A d d e n d u m

Iowa Department of Transportation
Office of Contracts

B.O.	Proposal ID	Proposal Work Type	County	Project Number	Addendum
001	08-C008-039	Bridge and Approaches – PPCB	Boone	IBRC-C008(39)--8E-08	18apr001.a02

Abutment keyway dimensions

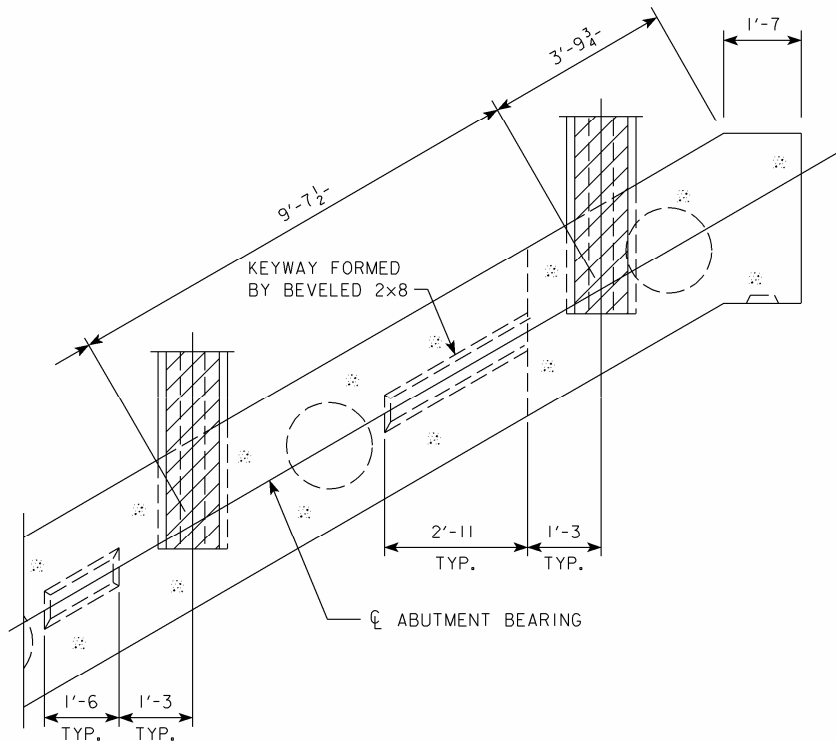
The following changes are a result of the Pre-Bid Meeting on April 5, 2006.

PART KEYWAY PLAN

Location of vertical reinforcing in the abutment

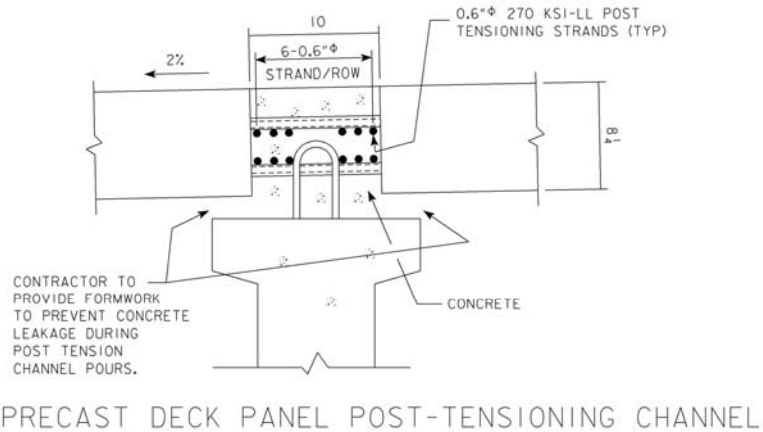
In the precast abutment footing the vertical 8g5 and 8g4 bars are to be placed with a minimum of 2" clear cover. The 8f1 longitudinal bars are to be placed interior of the vertical bars (towards the center of the precast footing each face).

Detail: Beam / Panel Joint – Contractor to prevent concrete leakage.

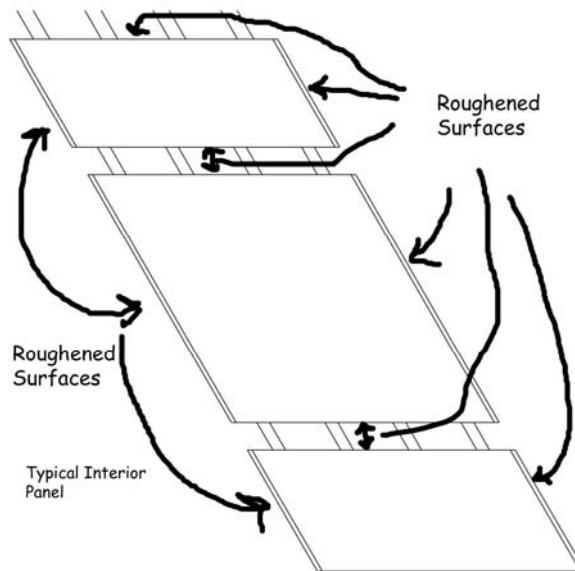
The plans, on Design sheet #19, incorrectly shows formwork intended to prevent leakage of concrete at the beam/panel joint. The method of preventing concrete leakage at the joint is left to the contractor. The correct detail is shown below.
